**PARK CITY PLANNING COMMISSION MEETING
SUMMIT COUNTY, UTAH
April 22, 2026**

Planning Commission Staff Report

Subject: 1885 Lower Iron Horse Loop Road
Applications: PL-25-06456 – Zone Change
PL-26-06861 – Conditional Use Permit
PL-26-06842 – Master Planned Development
Authors: Alec Barton, Senior Planner
Virgil Lund, Planner II
Jaron Ehlers, Planner I
Date: April 22, 2026
Type of Item: Work Session

Figure 3: Applicant's Slope Map

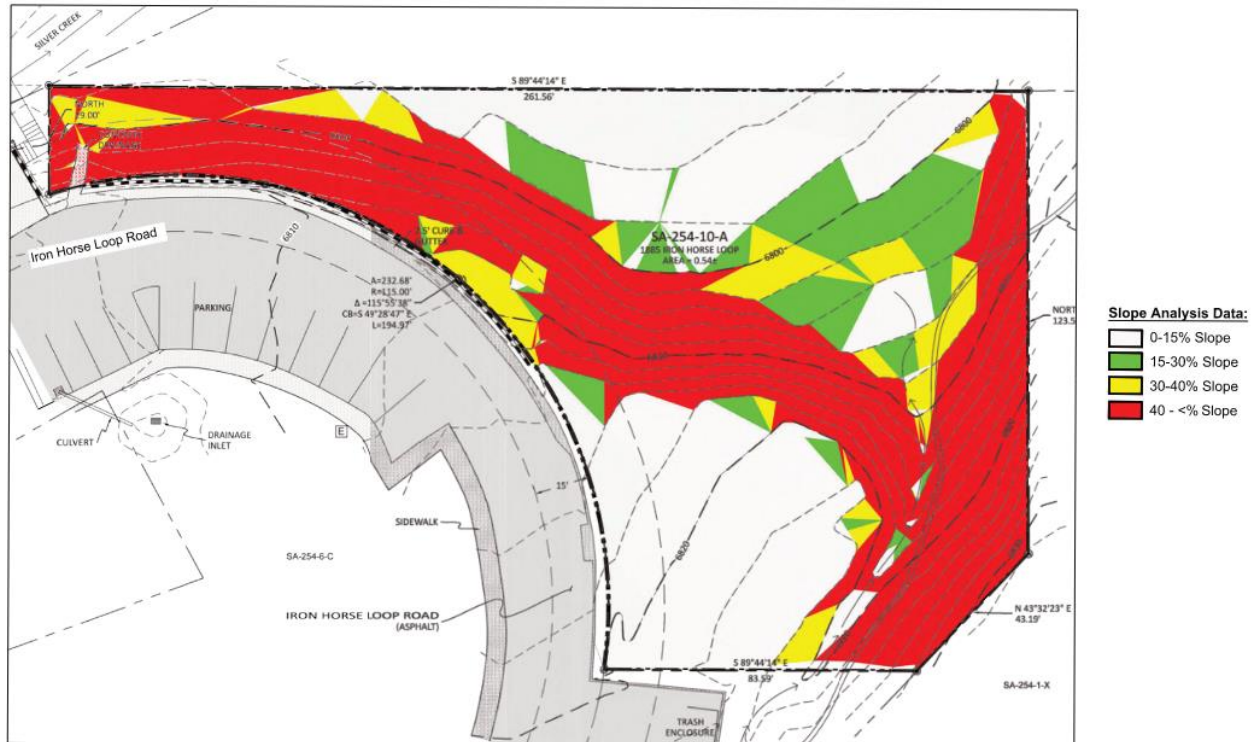
Pursuant to LMC [§ 15-6-5\(G\)](#), MPDs shall be designed to take into consideration the characteristics of the Site upon which it is proposed to be placed. The project should be designed to fit the Site, not the Site modified to fit the project. The Applicant shall address the following in the Site planning for an MPD:

- How cut or fill can be minimized.
- How the site can be designed to minimize retaining walls and limit the disturbance area.
- How the site plan minimizes changes to the viewshed from public areas, including the Rail Trail.
- How the proposed density and massing is designed to minimize impacts to the Steep Slopes and Very Steep Slopes.

Does the Planning Commission require additional information to evaluate the Sensitive Lands?

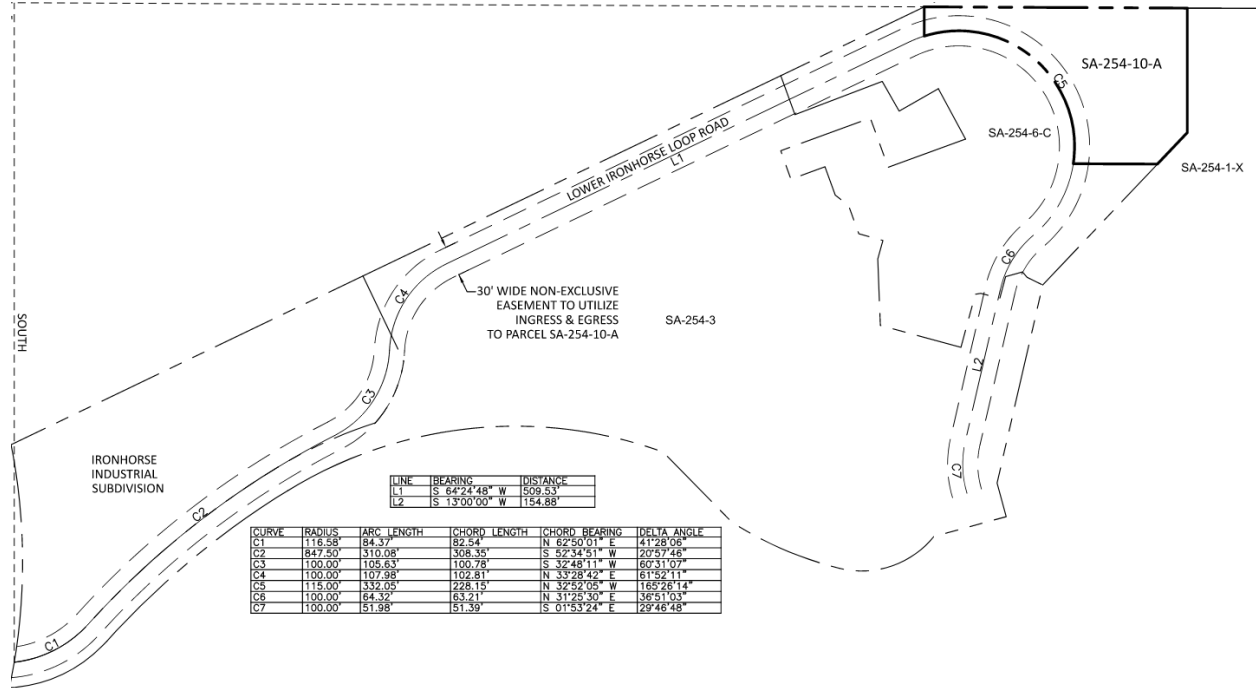
The Applicant's elevation drawings show a transition of roof elements from flats roofs to slightly pitched roofs every 20-30 feet. The proposal complies with the Façade length variation requirements in LMC [§ 15-5-8](#).

Does the Planning Commission require additional information to evaluate the Applicant's requested Building Height exception?

Figure 11: Applicant's Proposed Parking in Front Setback

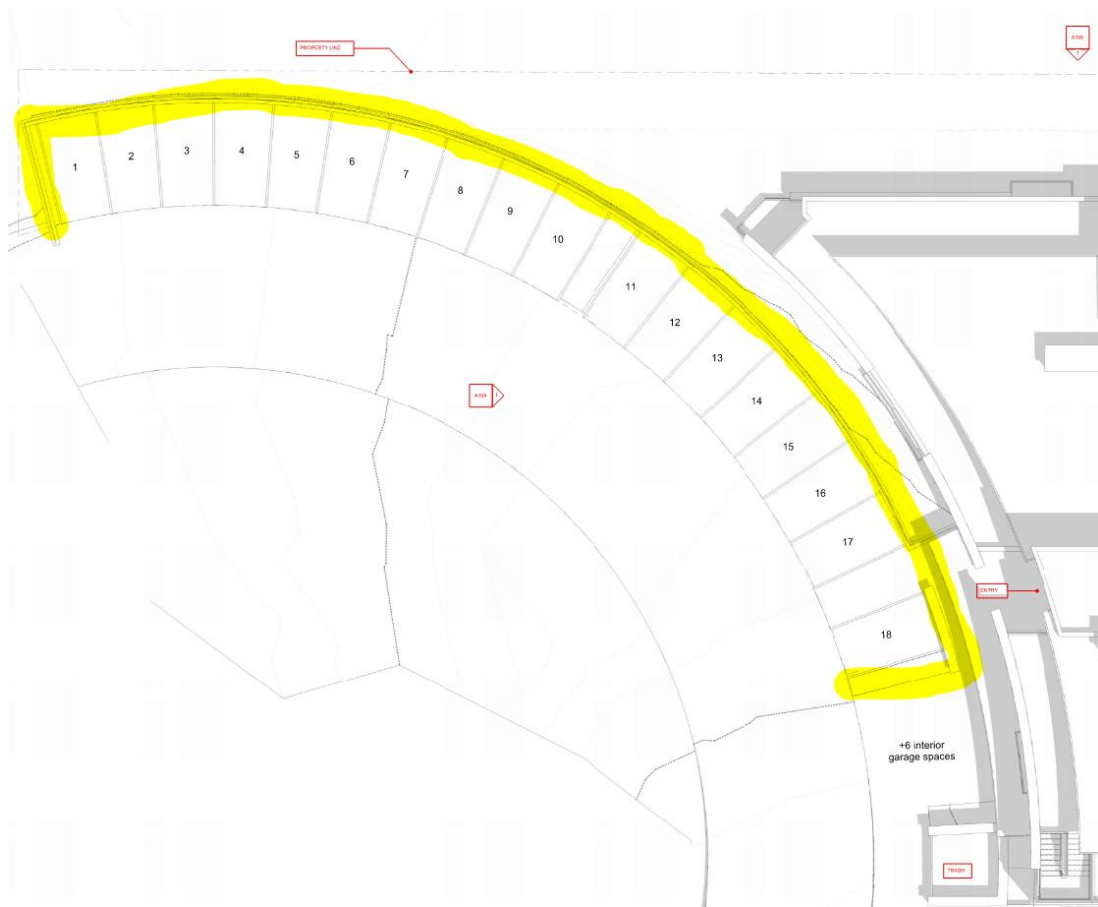
(IV) The site is accessed through a private easement, and the Applicant proposes parking within the Front Setback that requires access and reversing onto adjacent property.

Does the Planning Commission require additional information to evaluate the parking?
